expansion for the Volvo brand, a 2,164-square-foot car wash facility, and associated improvements.

09-108Z/PDP/FDP
Rezoning/Preliminary Development Plan/
Final Development Plan
MAG Volvo
6335 Perimeter Loop Rd.

PROPOSED LANDSCAPE PLAN

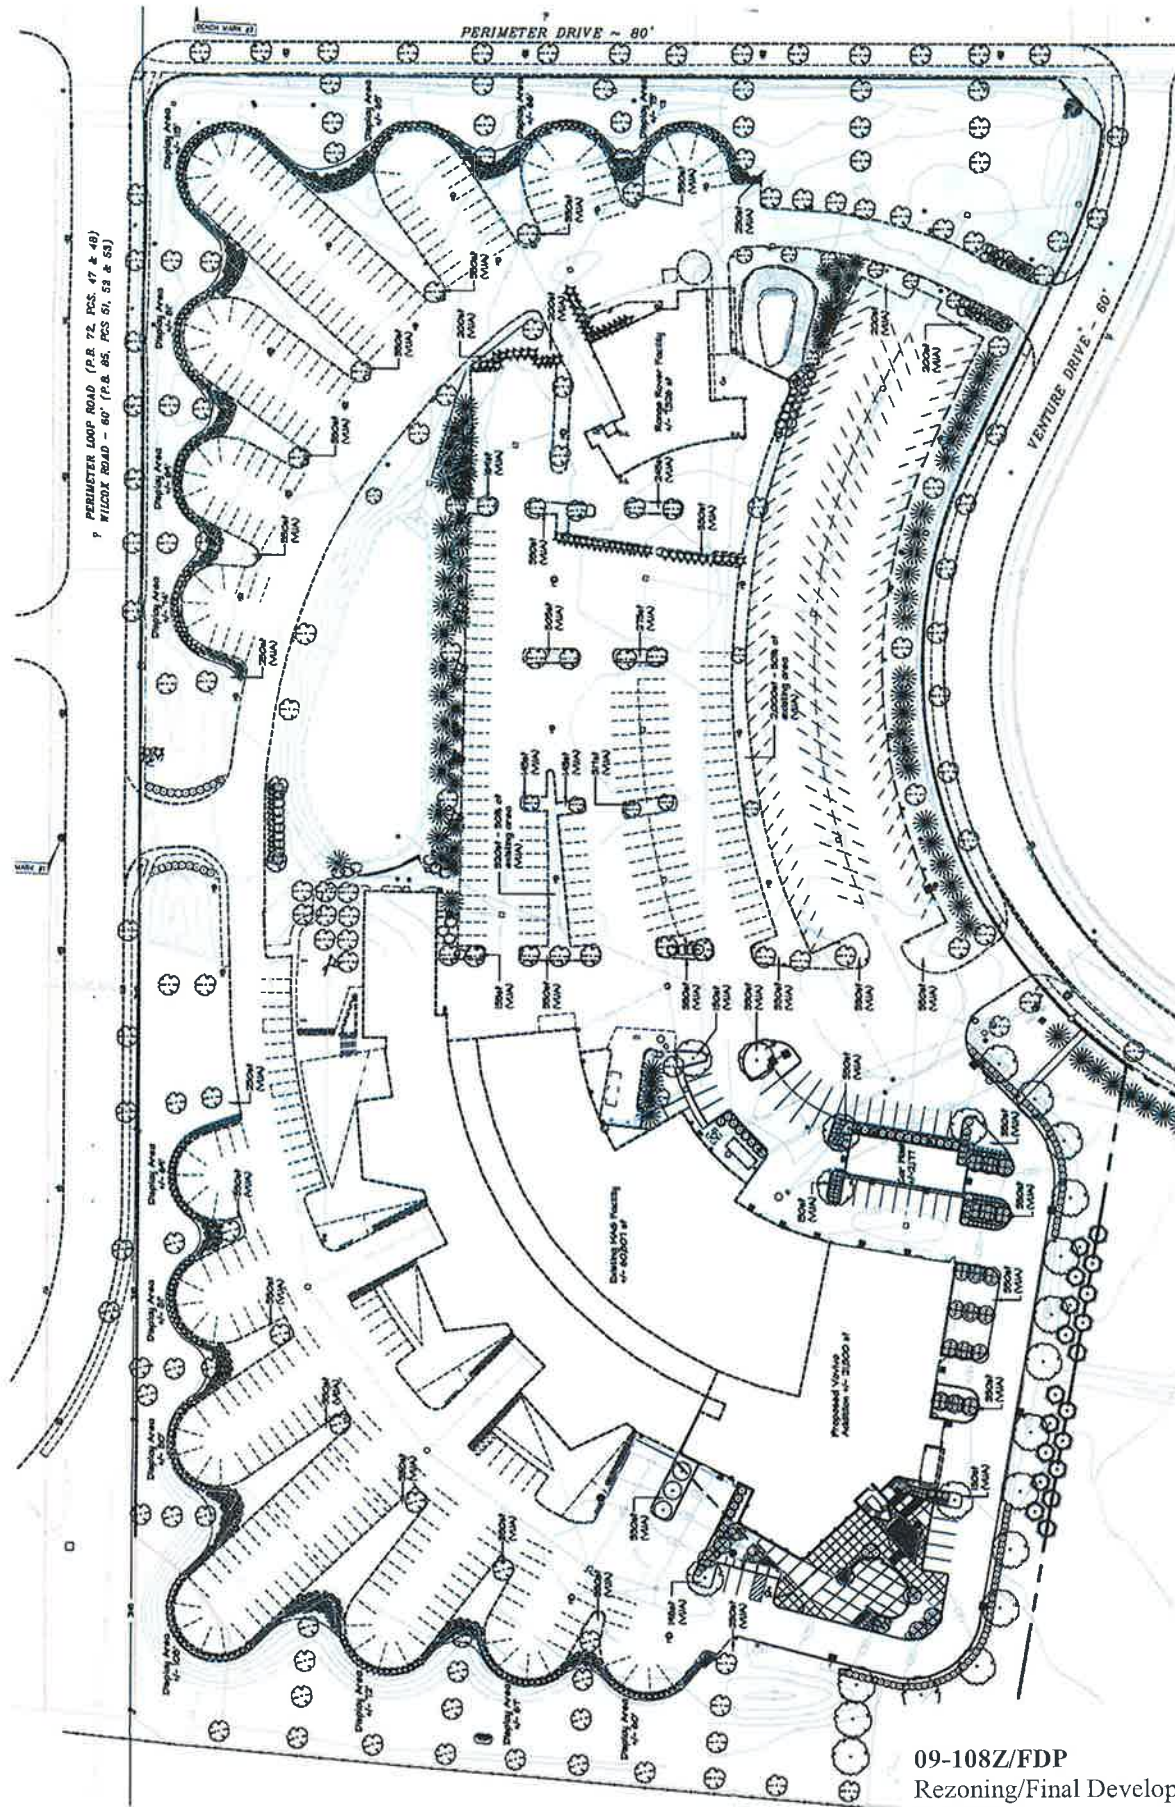
The text requires compliance with the Code’s landscaping requirements which are met, with the exception of interior landscaping and property perimeter buffering requirements. The plans will need to be revised to account for an additional 337 square feet of interior landscape area and three trees to meet the interior landscaping requirement.

Four additional trees will need to be planted along the SR161/US 33 frontage to meet the perimeter buffering requirements specified in the development text. The plans indicate deferred compliance with screening required along the eastern boundary to account for the future expansion of the BMW site to the east. The plans and the text note that if the BMW site is not complete within three years the appropriate screening must be installed.

Criteria met with conditions. The proposed plans meet the preliminary plan with regard to landscaping with the following exceptions. The plans will need to be revised to account for an additional 337 square feet of landscape area and three trees to meet the interior landscape requirement (Condition 1). Four additional trees will need to be planted along the SR161/US33 frontage to meet the planting requirements specified within the development text (Condition 2).

- 1) The plans be revised to account for an additional 337 square feet of landscape area and three trees to meet the interior landscape requirement;

- 2) Four additional trees will need to be planted along the SR161/US33 frontage to meet the planting requirements specified within the development text;
- 3) The directional Sign S be removed from the pole and ground-mounted to be consistent with the existing directional signs;
- 4) The Volvo wall sign indicated on the final development plans be removed and a brand ground sign be permitted adjacent to the Volvo entrance to coordinate with the existing brand signs on the MAG campus;
- 5) A stormwater easement will need to be provided, subject to approval by Engineering.
